SERVICE BULLETIN NO. MSB306-38

TCDS-No. 306 (FAA TC No. G33EU):
ASTIR CS S/N 1001 - 1536

Inspection of the vertical stabilizer attachment

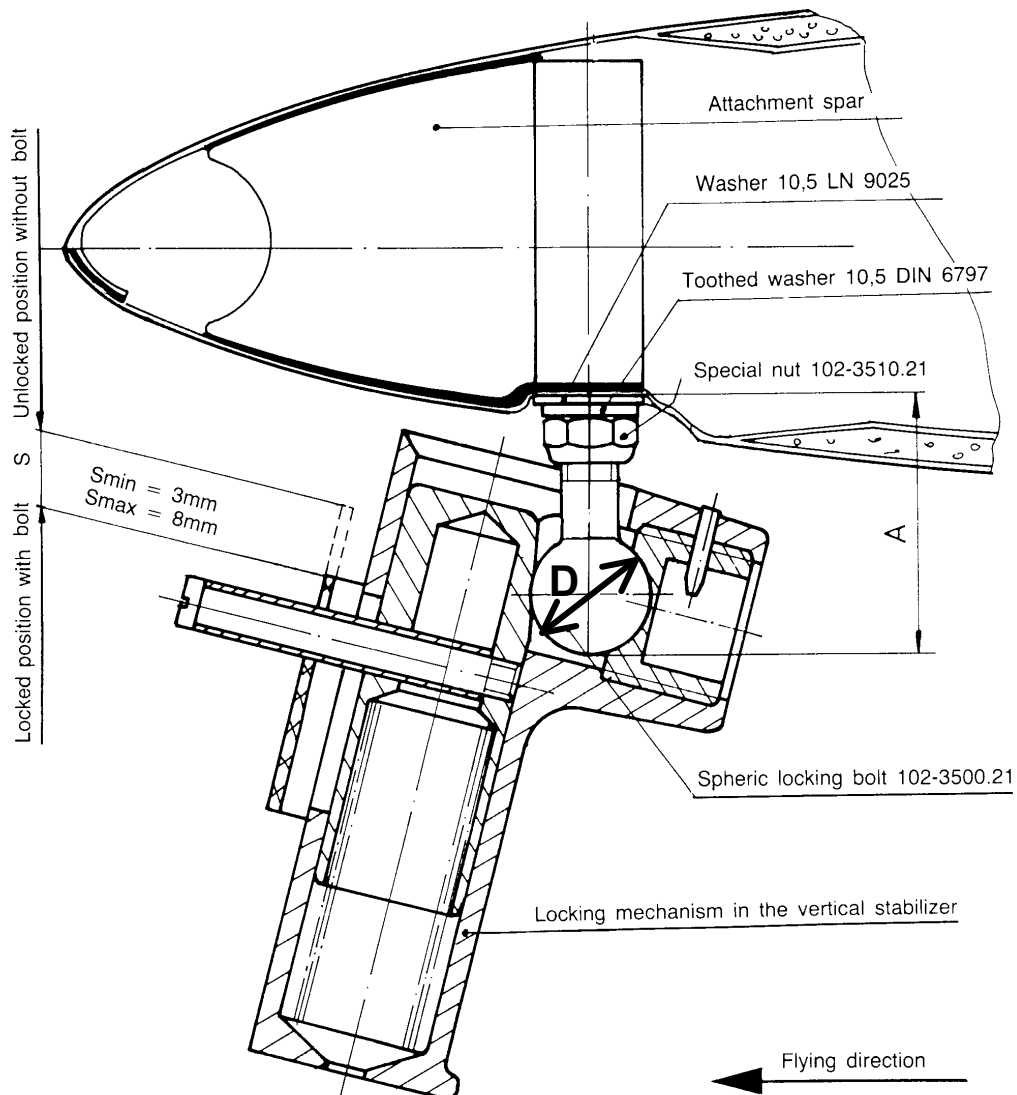
1.8.1 Check front and rear attachment of the stabilizer for noticeable play before de-rigging the horizontal stabilizer. Therefore move the stabilizer at the tips carefully to all directions.

- if no play is noticed, perform further action according to para 1.8.2
- if play is noticed in the front attachment
 - the spherical bolt must be replaced (see para 1.8.2). Determine the ball diameter. During order advise the measured diameter "D" + 0.1 mm.
- if play is noticed in the rear attachment
 - the retaining pins 102-2142.46 must be replaced (refer to Flight Manual ASTIR CS Chapter "Maintenance")
 - is further play noticeable after replacement of the bolts, the bearings in the stabilizer spar web must be replaced (refer to Flight Manual ASTIR CS Chapter "Maintenance")

1.8.2 Inspect and replace the spherical locking bolt as follows:

- remove horizontal stabilizer according to the Flight Manual and lay down in a proper device
- determine and note the exact installation depth "A"

NOTE: The exact determination is very important for the re-installation not to change the stabilizer angle of incident.

- loosen the hexagon nut P/N 102-3510.21 (14 mm wrench) and remove spherical bolt using a screw driver
- inspect the thread of the bolt (especially in the area nut/ socket) for cracks or damage (using magnifying glass x20 or dye penetrant testing)
- if a crack or any indication for crack starting is found, the bolt must be replaced immediately

NOTE: During order of a new spherical bolt P/N 102-3500.21 the exact diameter "D" must be advised with tolerance ± 0.1 mm.

- install the inspected or new spherical bolt, thereby pay attention for the correct installation depth
- tighten hexagon nut P/N 102-3510.21 with torque 20 Nm (tolerance +4, -2) holding the bolt using a screw driver
- install horizontal stabilizer
- check and adjust if necessary the stabilizer angle of incident according to the Flight Manual
